Site Plan #105 (PenPlace)

Site Plan Review Committee (SPRC)

December 6, 2021

Pavilion 2 (and elsewhere)

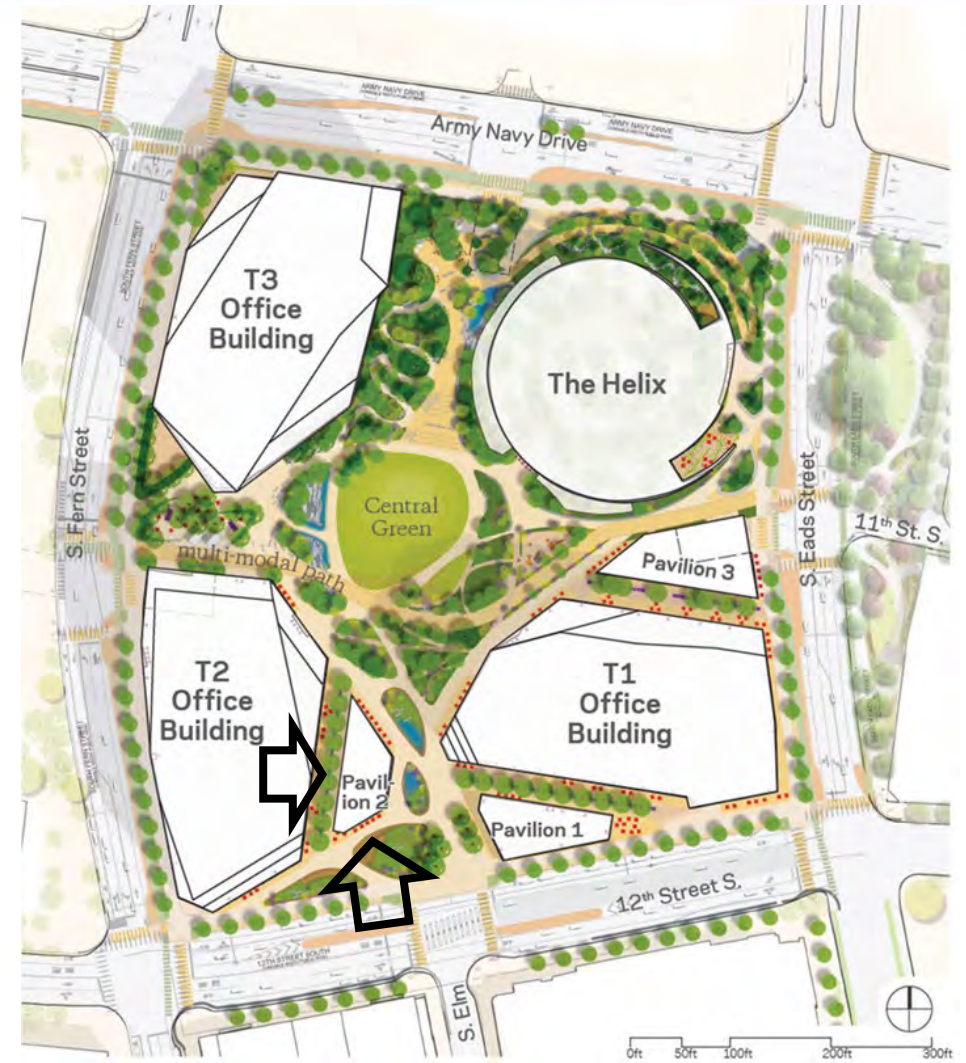
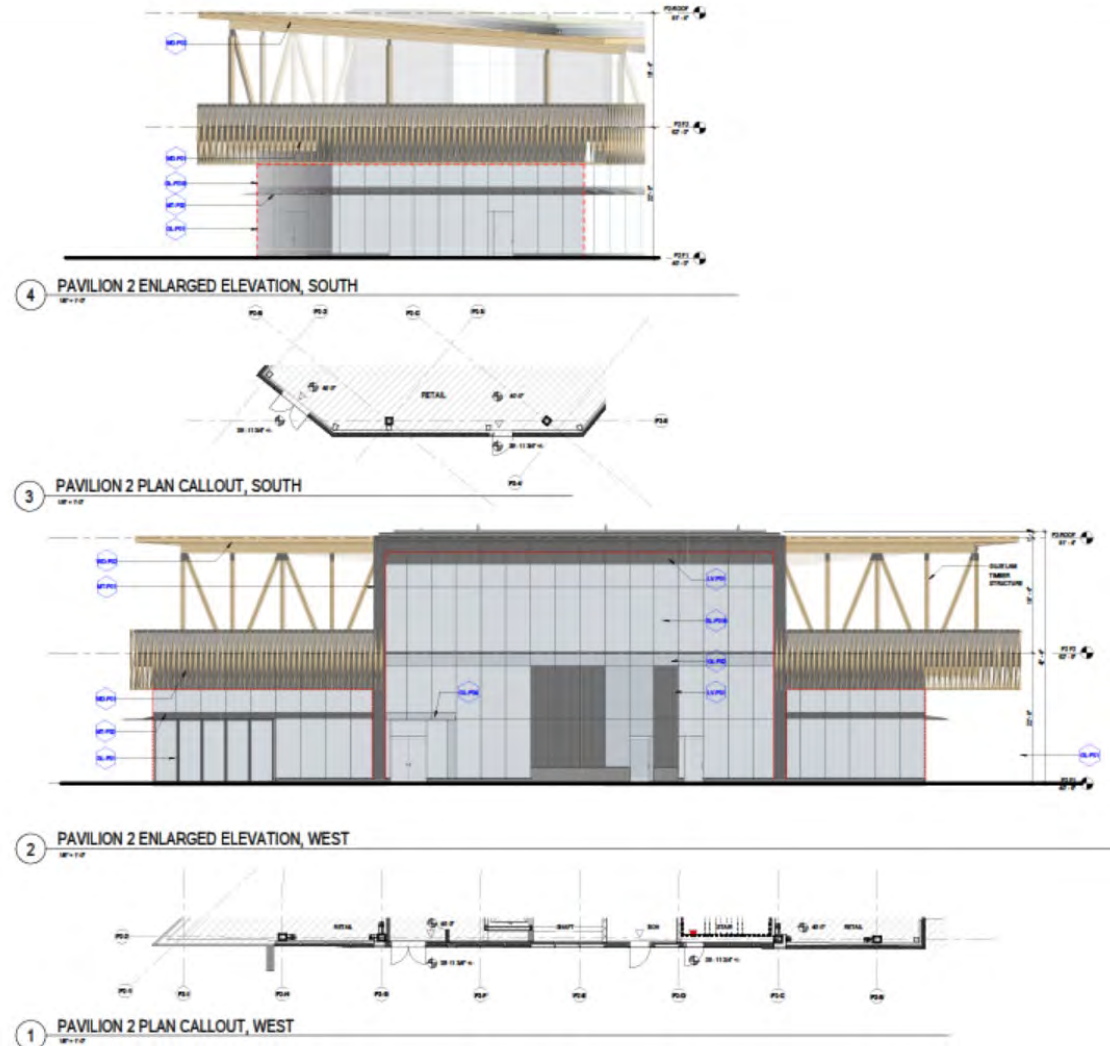
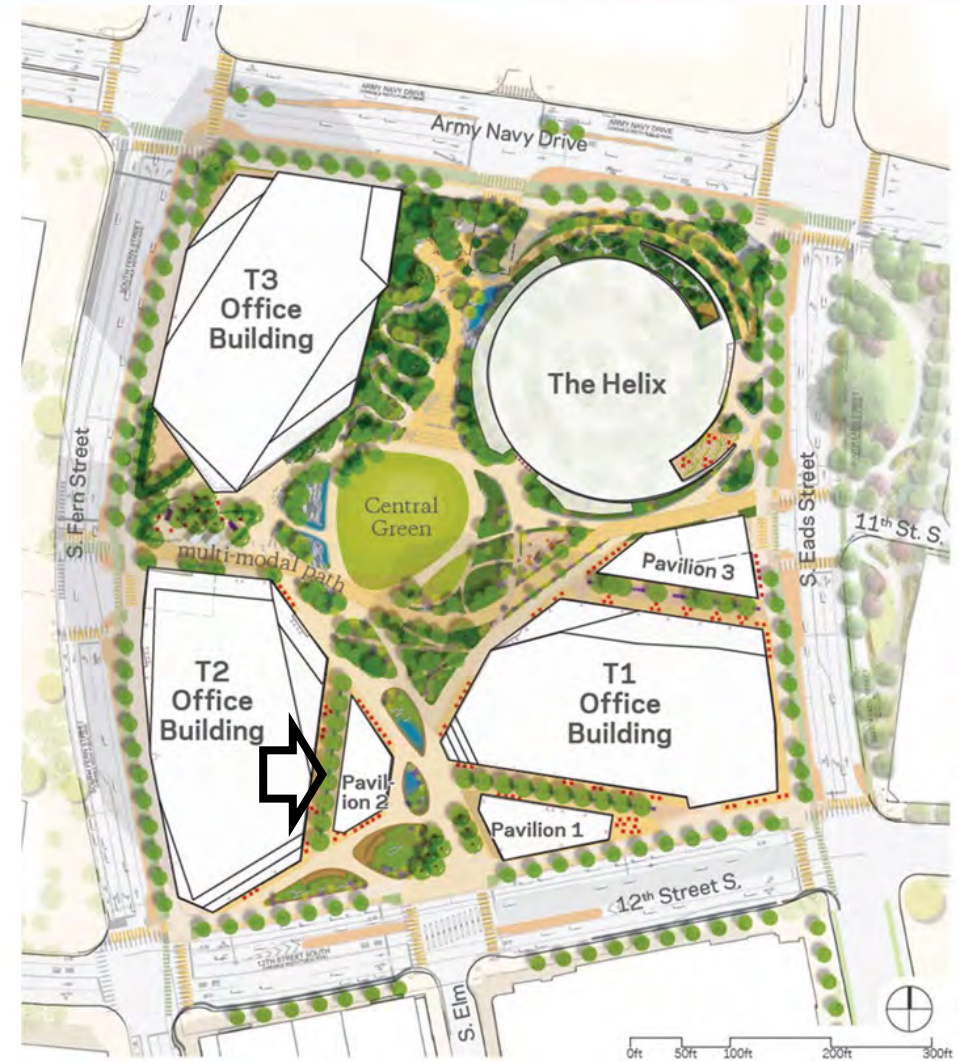
- The active part of the louvers are above pedestrian height only
